**STAFF RECOMMENDATION**  
**3111 Overlook Drive**  
**October 21, 2015**

**Application:** New construction-infill  
**District:** Hillsboro-West End Neighborhood Conservation Zoning Overlay  
**Council District:** 18  
**Map and Parcel Number:** 10410024200  
**Applicant:** Split Rock Development  
**Project Lead:** Paul Hoffman, paul.hoffman@nashville.gov

<p><b>Description of Project:</b> Applicant proposes to construct a new single-family residence on this vacant lot.</p> <p><b>Recommendation Summary:</b> Staff recommends approval of the project with the conditions:</p> <ol style="list-style-type: none"><li>1. The finished floor height shall be consistent with the finished floor heights of the adjacent historic houses, to be verified by MHZC staff in the field;</li><li>2. Staff approve the final details, dimensions and materials of windows, doors and garage doors prior to purchase and installation;</li><li>3. The HVAC shall be located behind the house or on a side facade, beyond the mid-point of the house; and</li><li>4. Staff approve the roof color and masonry color, dimensions and texture.</li></ol> <p>Staff finds the proposed infill meets the design guidelines for the Hills

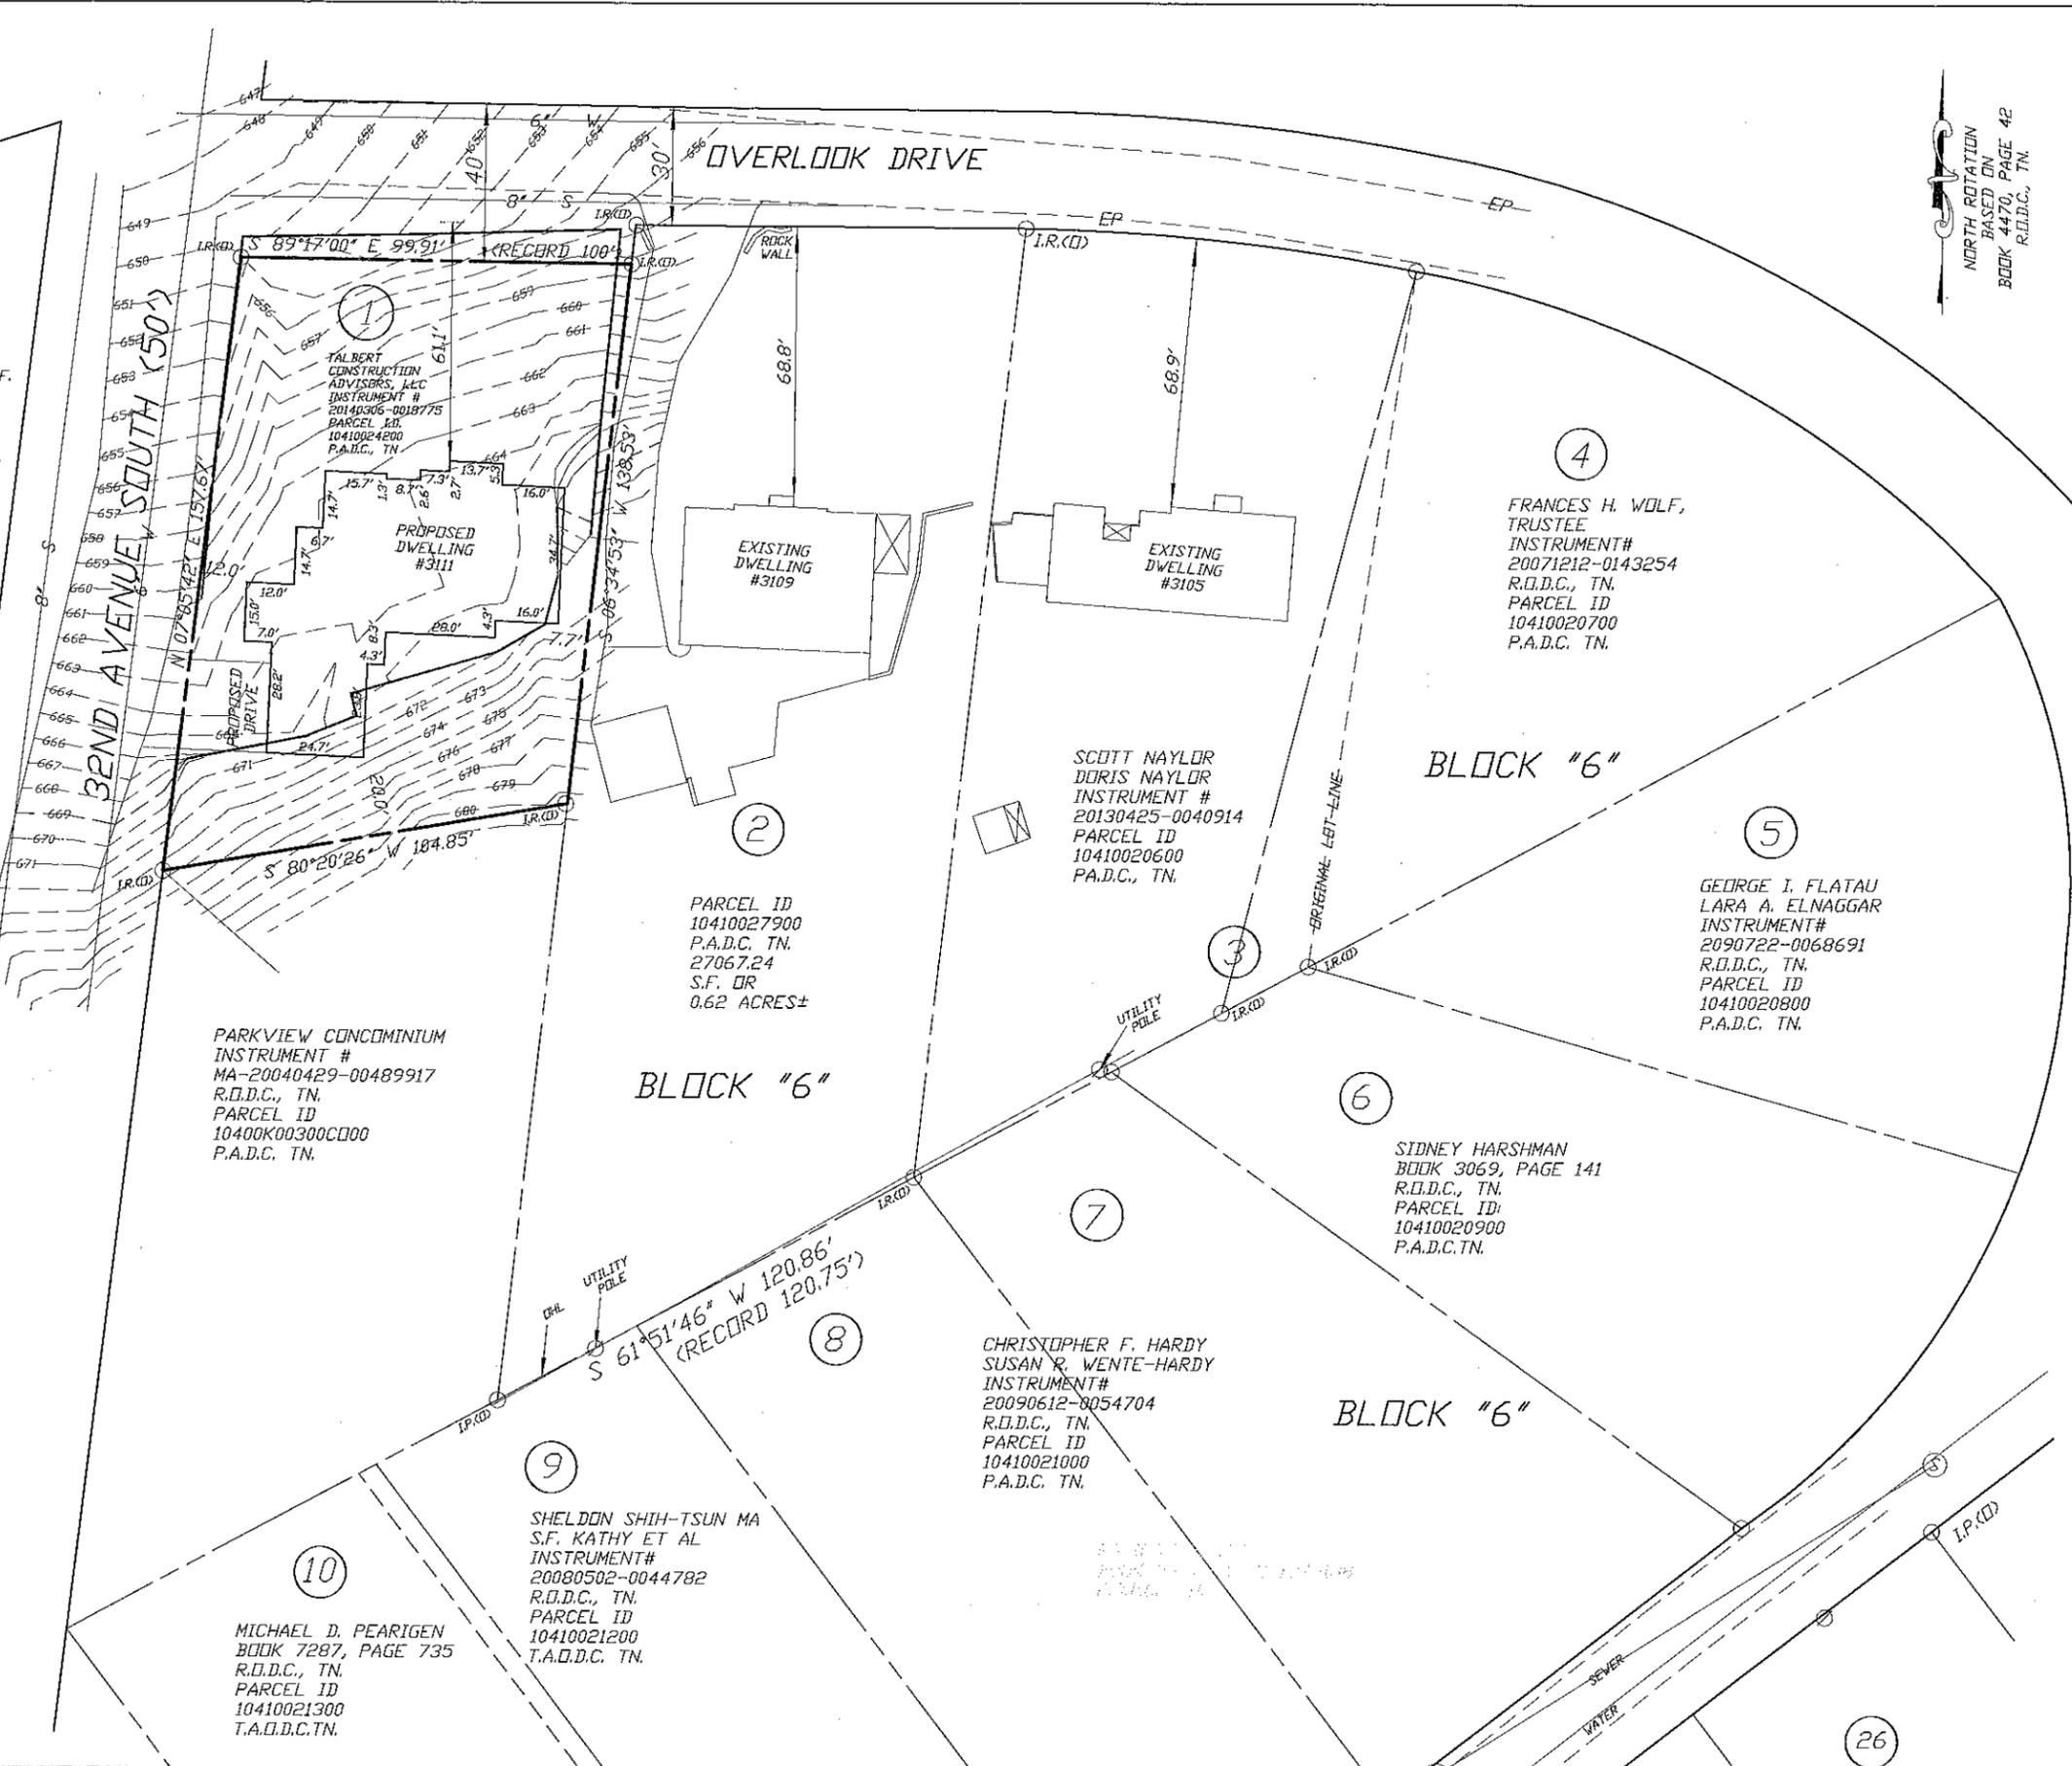
**Setback & Rhythm of Spacing:** The side setbacks are twelve feet (12') on the left, and seven feet, eight inches (7'8") on the right. The rear setback is twenty feet (20'). The proposed setbacks meet base setback requirements. The front setback of sixty one feet and one inch (61'1") is in line with the adjacent buildings. The project meets section II.B.1.c.

**FRONT ELEVATION**  
 SCALE: 1/4" = 1'-0"

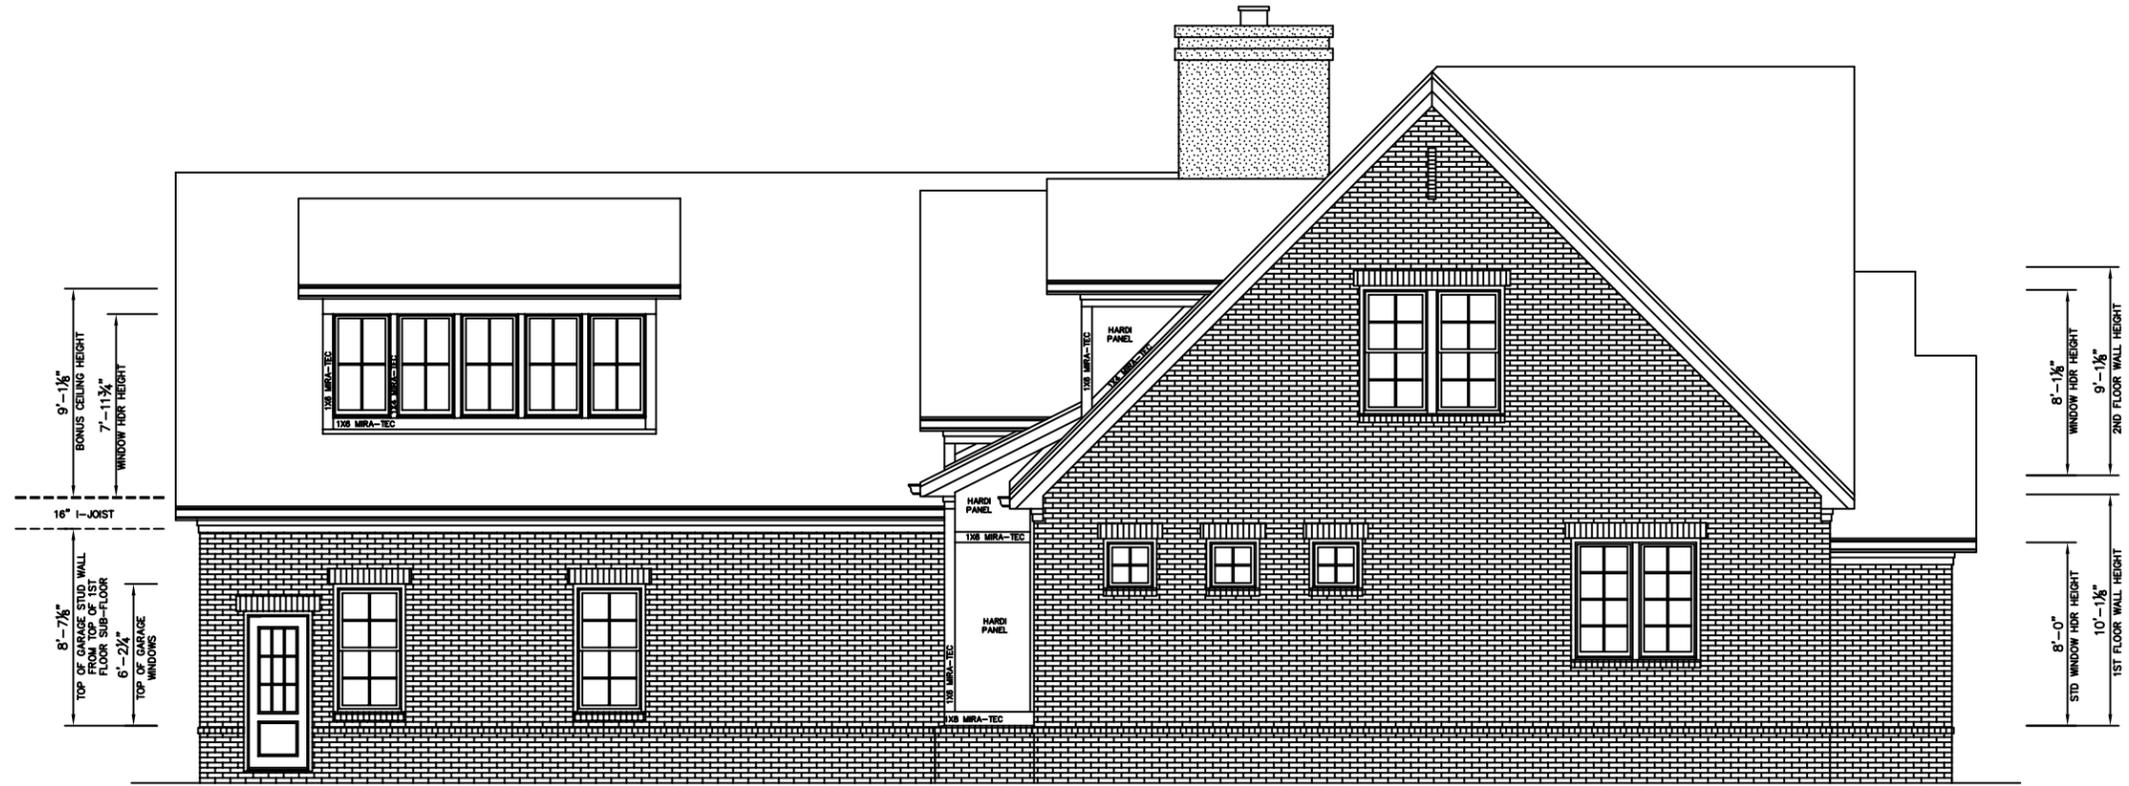
**Height & Scale:** The new structure's total height will be thirty-one feet (31') from grade. The foundation height is two feet (2'). Several contributing buildings on Overlook Drive and Hillside Drive are as tall as thirty-four feet (34'). The building is eighty feet (80') wide overall in an ell shape. Sprawling homes on larger lots are seen in this portion of the district, characteristic of homes built after World War II. Contributing homes nearby

range in width from forty-two feet (42') to sixty-four feet (64'). Although the proposed building is wider than those dimensions, Staff finds the building is appropriate here, as the lot is very shallow compared to other long lots in the neighborhood, the building area is limited, with significant grade in both the front and rear yards and much of the length is set back from the front wall, between fourteen and twenty-eight feet (14'-28') back. It is also approximately the same width as the previous residence on the site. Staff's analysis is that the project meets section II.B.1.a. and b.

**Roof form:** The house is cross-gabled; the gables and gabled dormers all have 12/12 pitch. Shed dormers on the front and left side have 4/12 pitch. Staff finds that the proposed roof form will not contrast greatly with those of surrounding historic buildings. The project meets section II.B.1.e.

**Orientation:** The house has a front porch addressing the street. The porch is six feet deep. Vehicular access will be via the attached garage, accessible from the side street.

Proportion and Rhythm of Openings: The windows are generally twice as tall as they are wide, thereby meeting the historic proportions of openings. Paired windows have the four to six inch (4-6") mullion typically requested by the Commission. The largest expanse of wall space without a window or door opening is twenty-four feet (24'). As this is on the rear wall of the garage, its visibility will be minimal. Staff finds the project's proportion and rhythm of openings to meet Section II.B.1.g.

1. The finished floor height shall be consistent with the finished floor heights of the adjacent historic houses, to be verified by MHZC staff in the field;
2. Staff approve the final details, dimensions and materials of windows, doors and garage doors prior to purchase and installation;
3. The HVAC shall be located behind the house or on either side, beyond the mid-point of the house;
4. Staff approve the roof color and masonry color, dimensions and texture.
